LEGAL NOTICE EXETER PLANNING BOARD AGENDA

**TOWN OF EXETER
PLANNING BOARD
NOWAK ROOM
10 FRONT STREET
AUGUST 14, 2025
DRAFT MINUTES
7:00 PM**

To: Planning Board

- Site plan set entitled "Mixed Use Site Plan 97 Portsmouth Avenue" last revised 8/18/2025, prepared by Beals Associates
- "Drainage Analysis & Sediment and Erosion Control Plan" last revised 6/24/2025, prepared by Beals Associates

Truck Turning Plan (Sheet T1, 15 of 15):

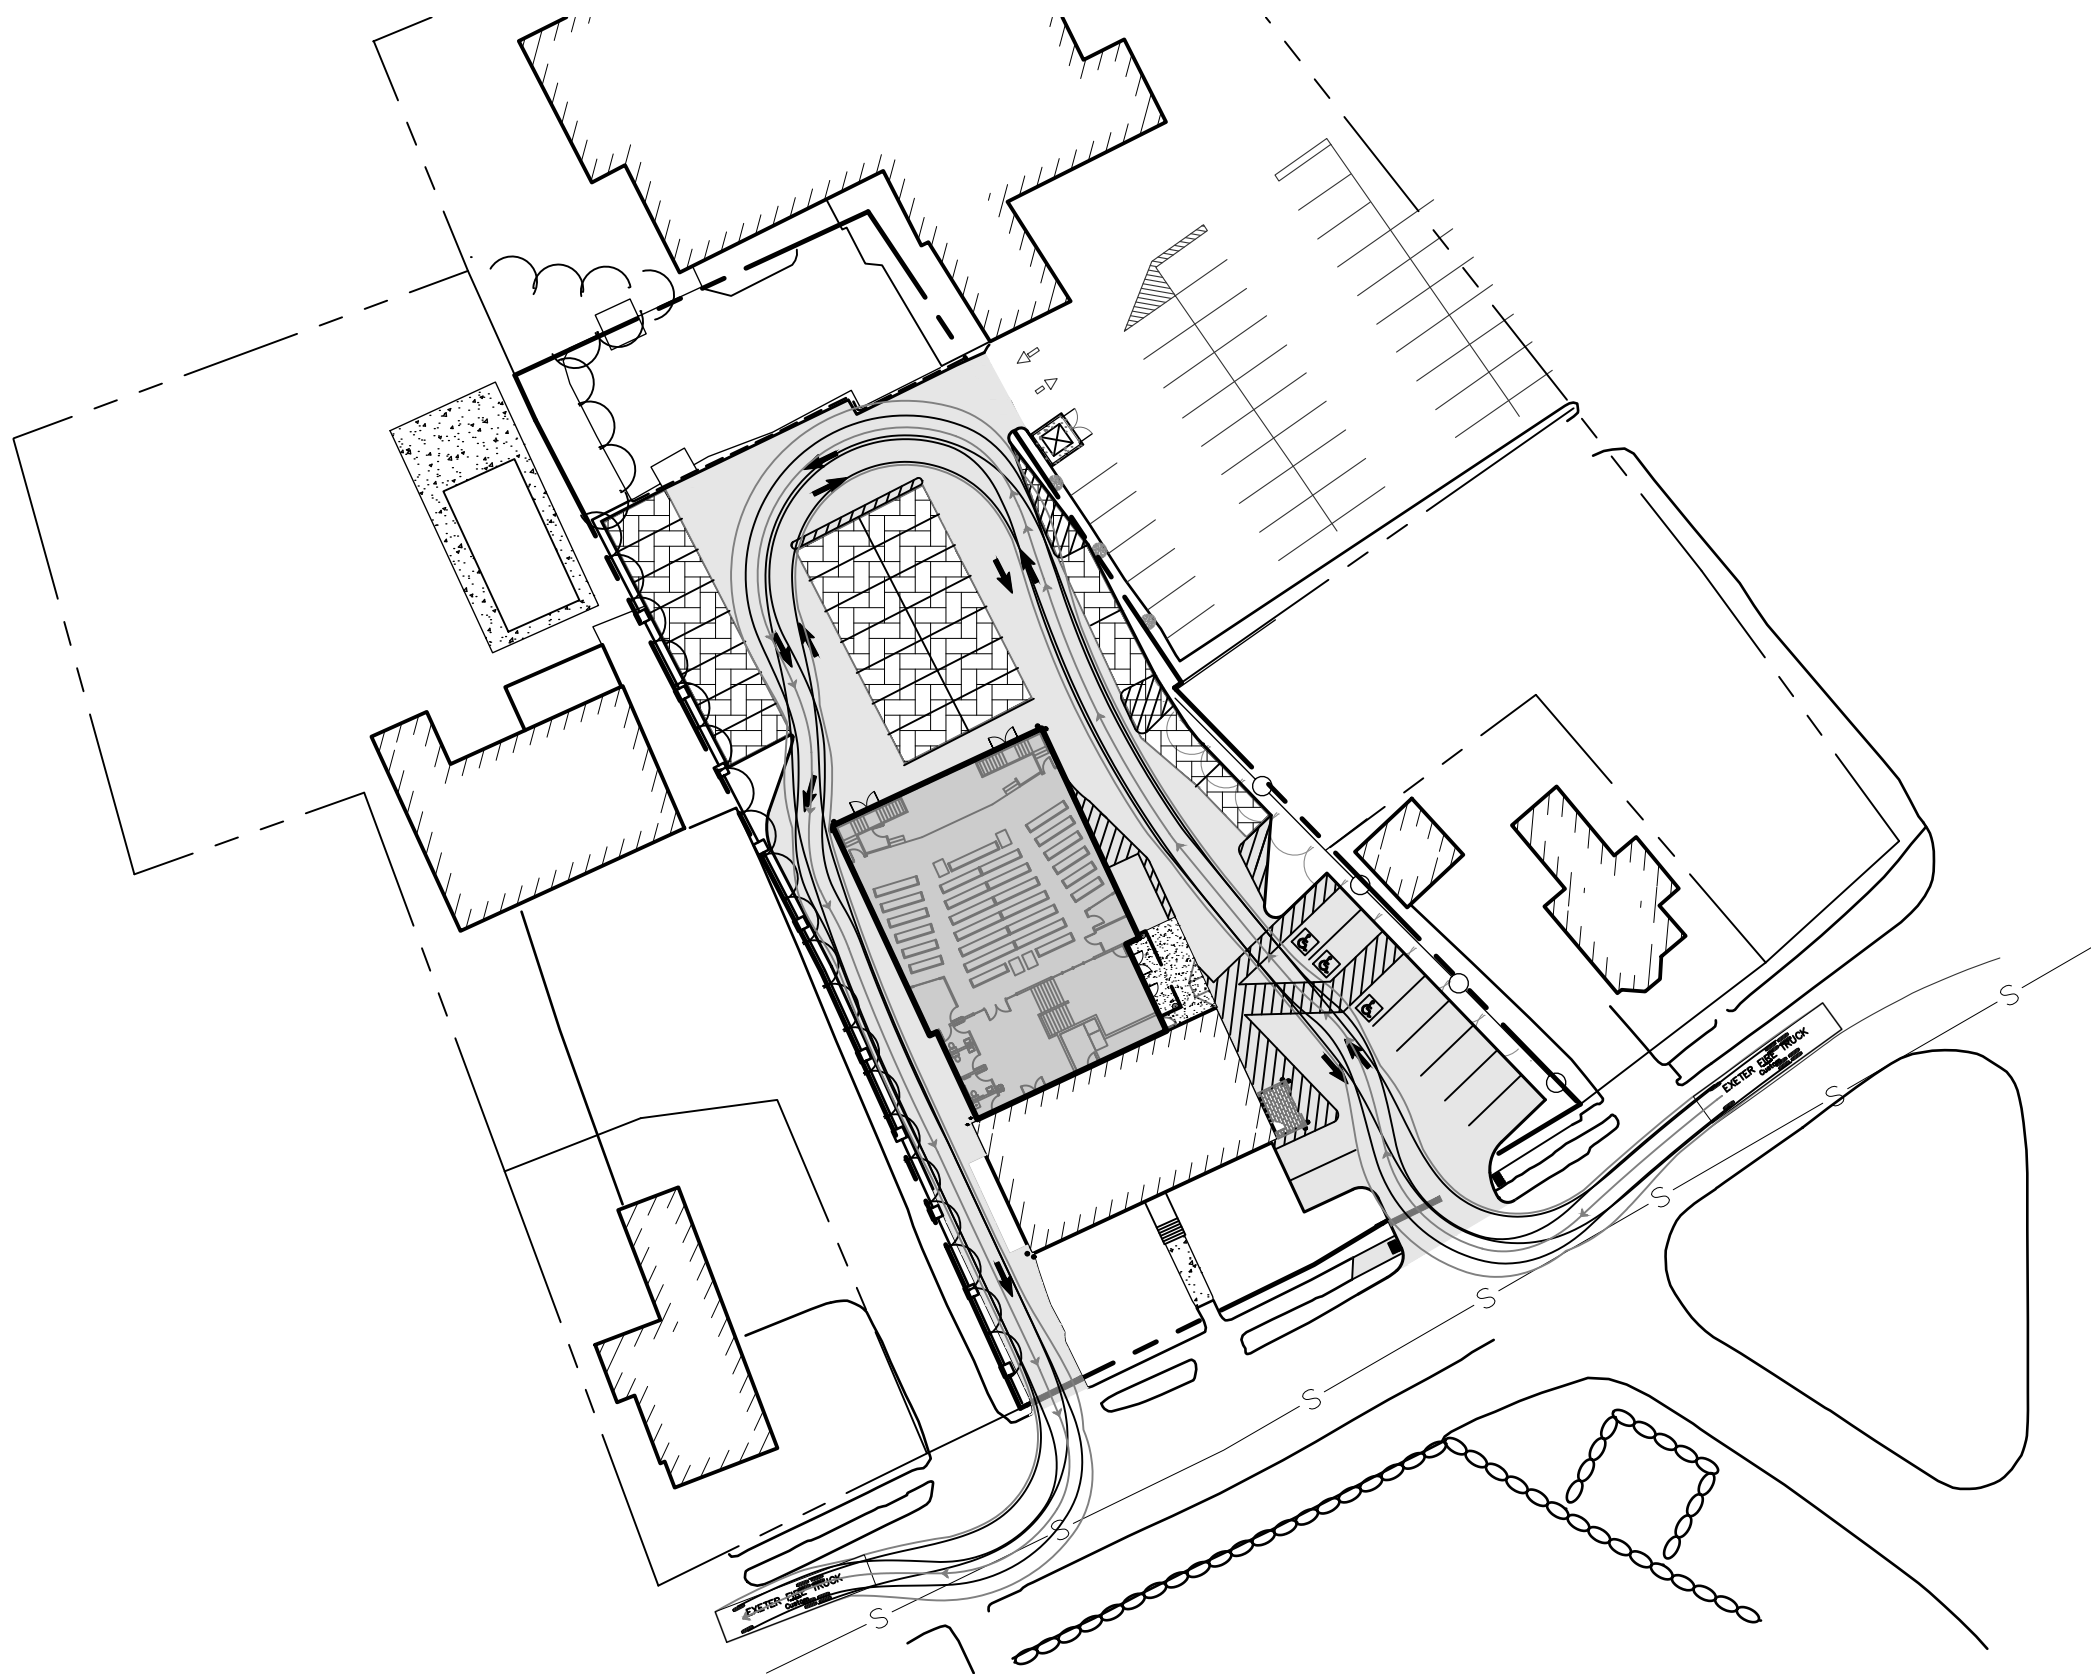
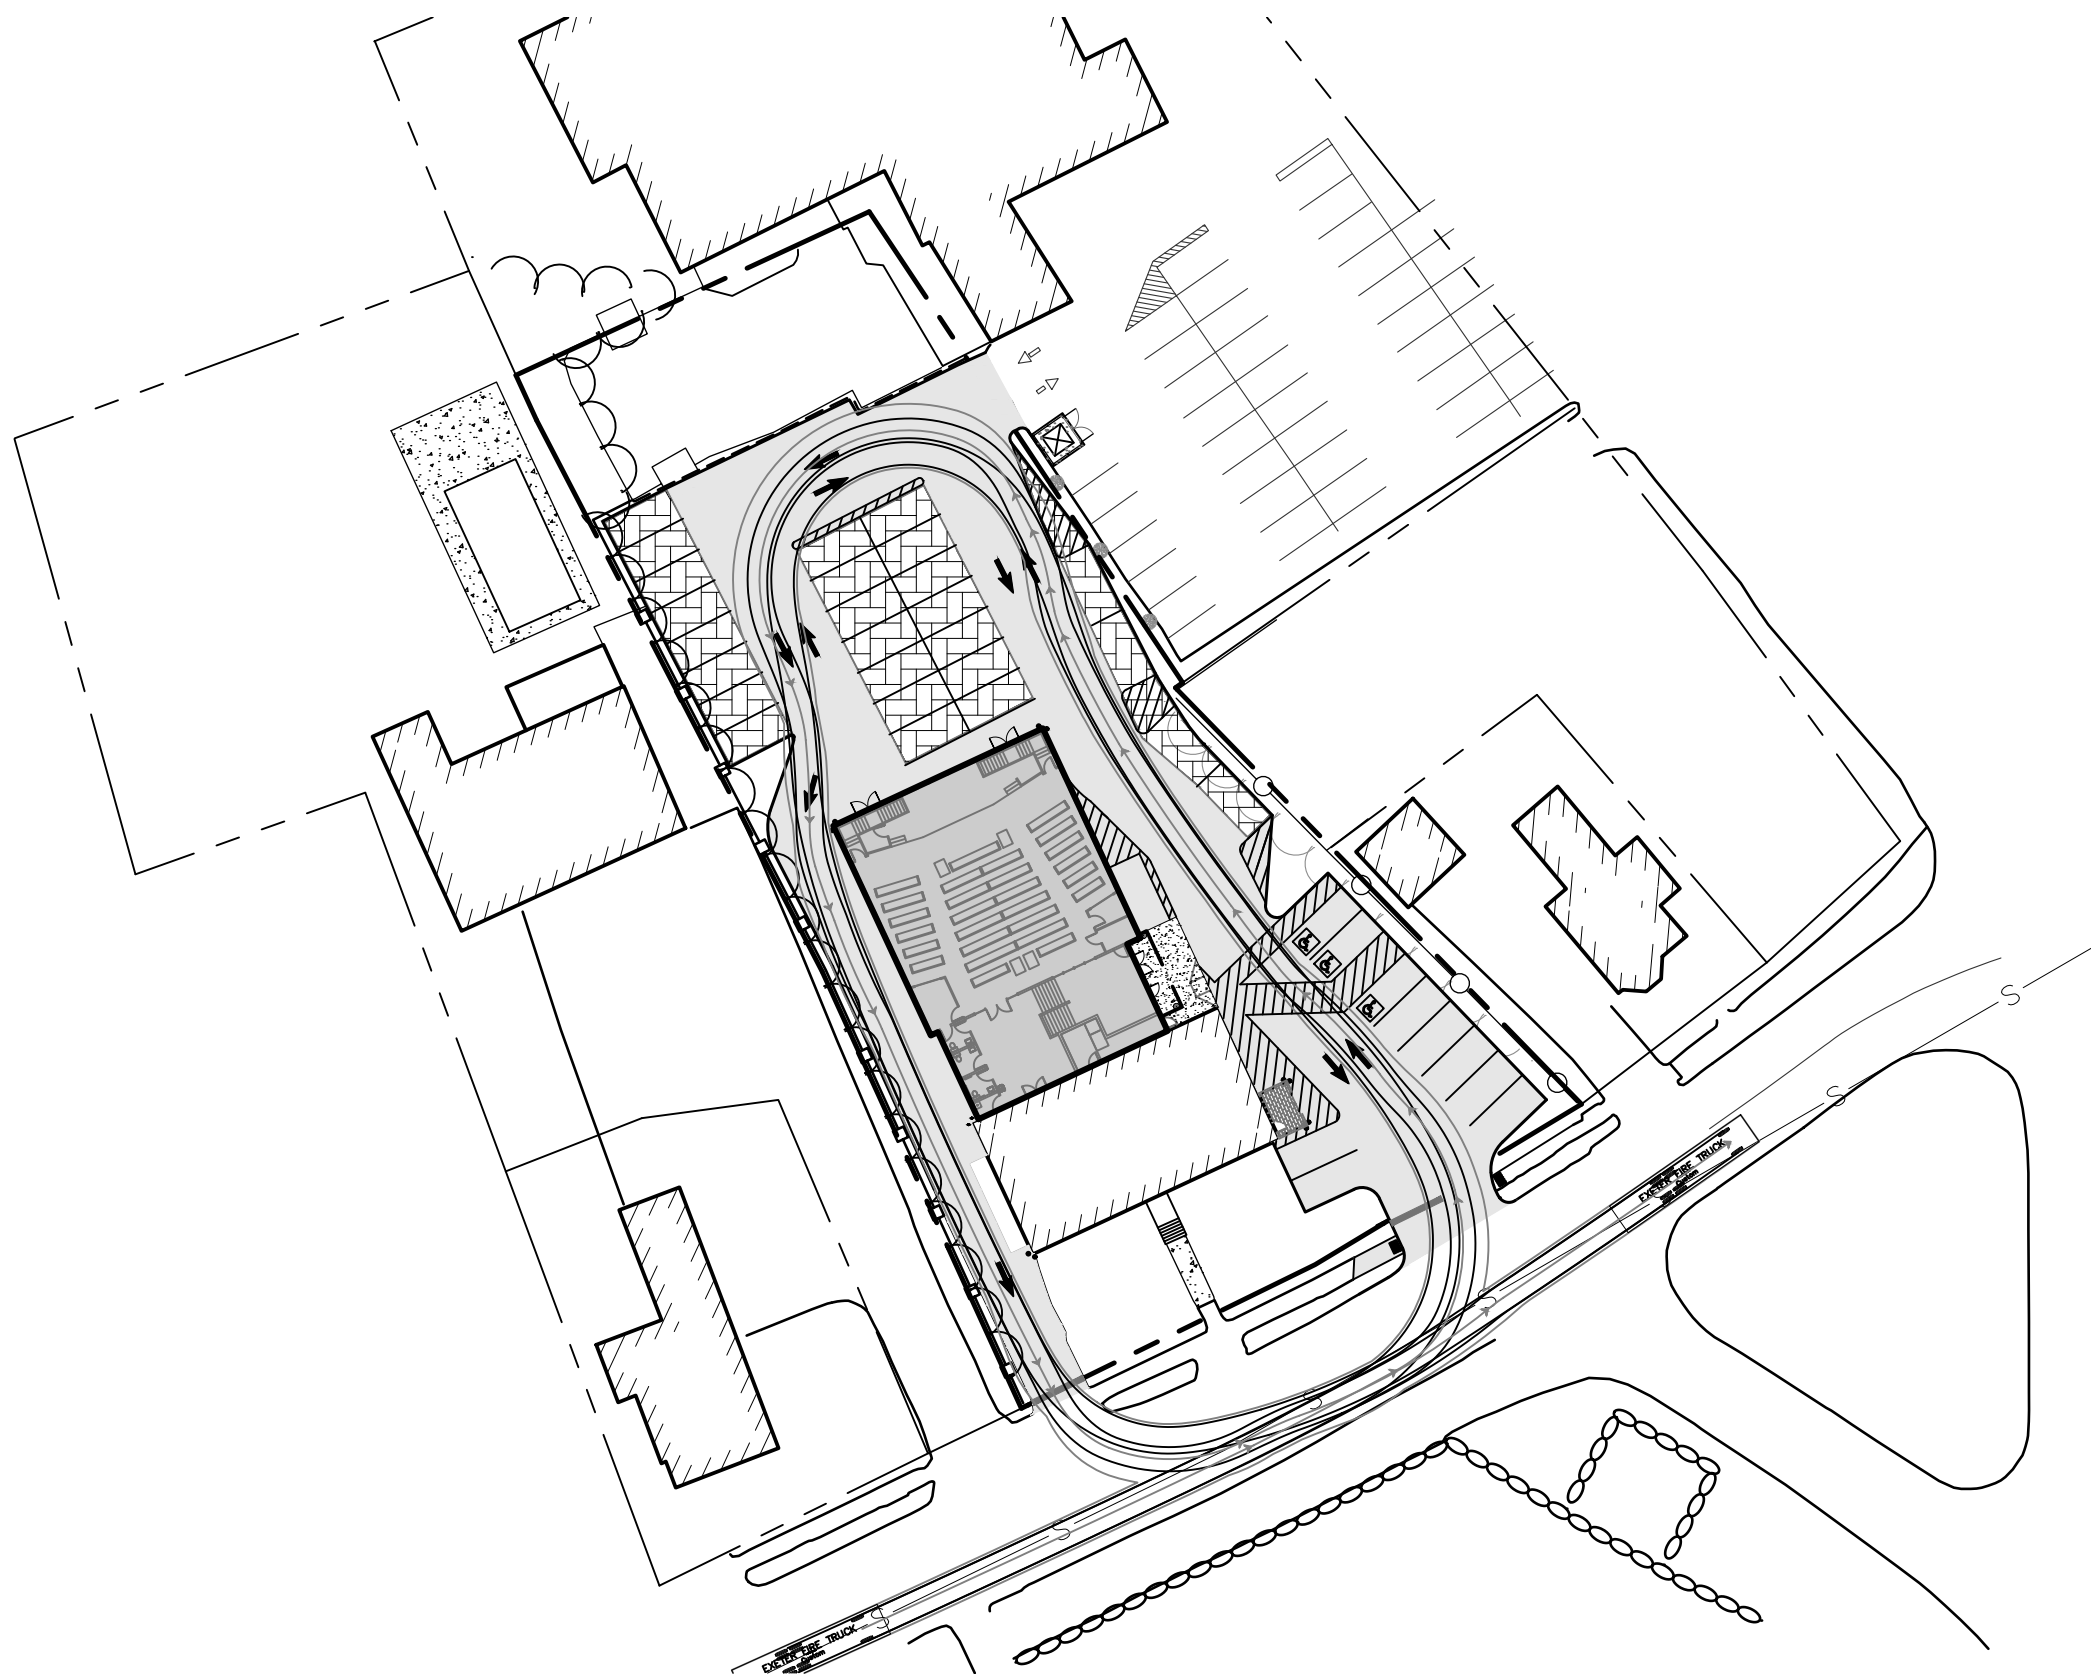
33. *Sheet T1 indicates that the truck used in the turning analysis has a wheelbase of 19.75 feet and vehicle length of 34.9 feet, however Exeter's Ladder #1 is a 2014 KME Predator 2000/500/109' RMA ladder truck with a wheelbase of 21.7 feet and length of 40.75 feet. Please coordinate with Exeter Fire regarding the truck access needs for the project.*
